PROJECT LAYOUT SHEET #4

PROJECT NAME: RICHMOND
PROJECT NUMBER: STP-RS 0284(11)

FILE NAME: z90c092_L04_14.dgn
PROJECT LEADER: D.E.G.
DESIGNED BY: B.T.H.
DWG. NO.: P-4

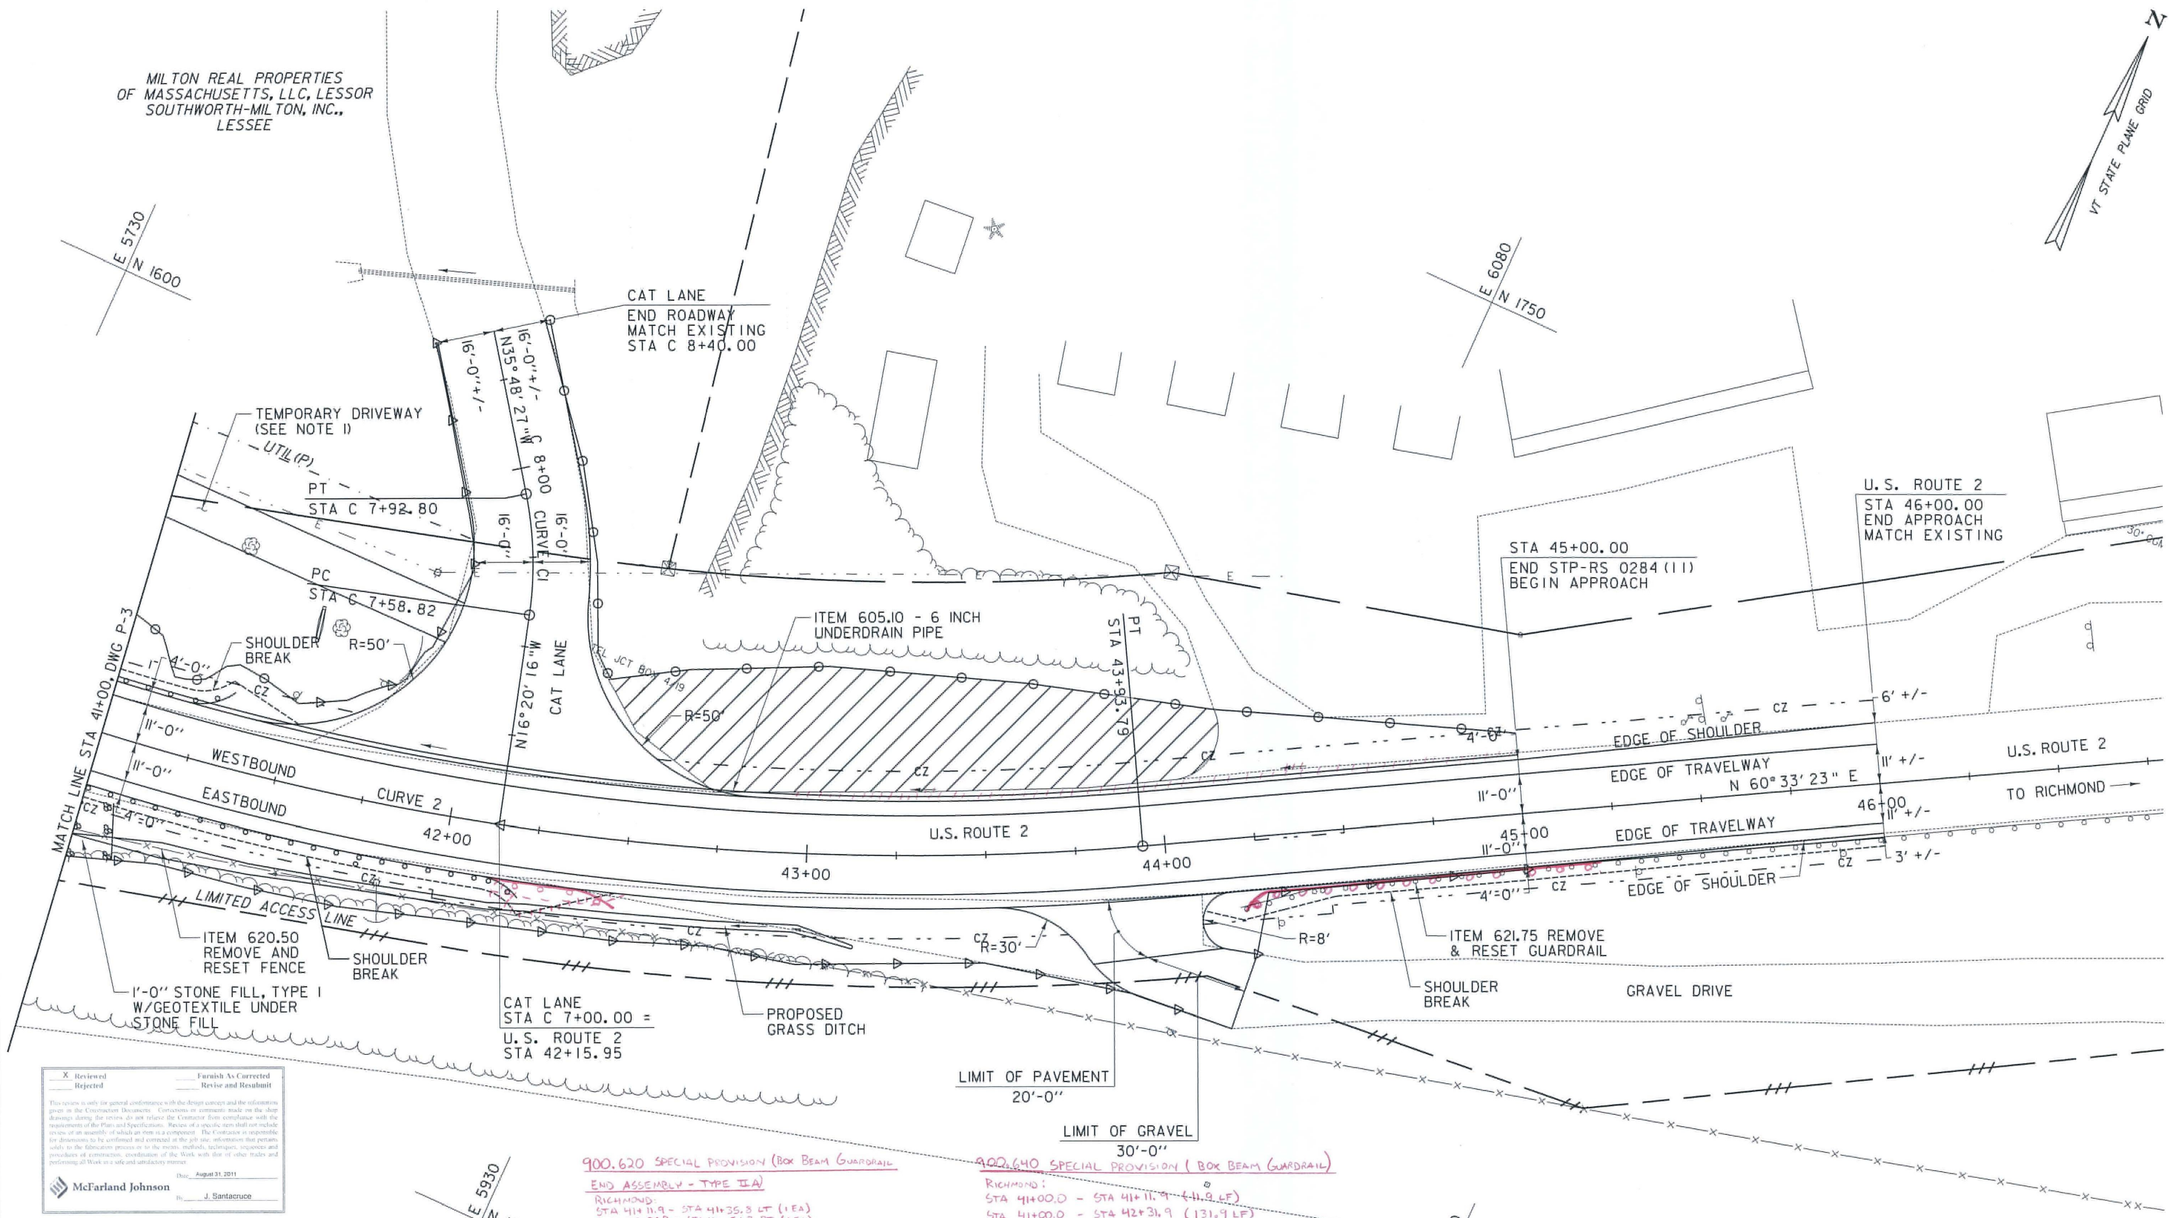
1. TEMPORARY DRIVEWAY SHALL REMAIN IN PLACE TO ALLOW ACCESS TO UTILITY POLE.

605.95 UNDERDRAIN FLUSHING BASIN
RICHMOND: 42+80.0
STA ~~42+87.0~~ LT
~~STA 45+00.0 LT~~

605.10 6 INCH UNDERDRAIN PIPE
RICHMOND: 42+80.0 180.0
STA 41+00.0 - STA ~~45+00.0~~ LT (~~400.0~~ LF)

621.20 STEEL BEAM GUARDRAIL, GALVANIZED
RICHMOND:
~~STA 41+00.0 - STA 41+34.9 LT (34.9 LF)~~
~~STA 41+00.0 - STA 42+21.9 RT (121.9 LF)~~
STA 44+19.5 - STA 46+19.5 RT (100.0 LF)

621.60 ANCHOR FOR STEEL BEAM RAIL
RICHMOND:
~~STA 41+28.4 RT~~ STA 44+19.5 RT
~~STA 42+15.4 LT~~

621.~~75~~ 80 REMOVE AND ~~RESET~~ DISPOSAL GUARDRAIL
RICHMOND:
STA 44+19.5 - STA ~~46+00.0~~ 45+19.5 LT (~~180.5~~ 100.0 LF)
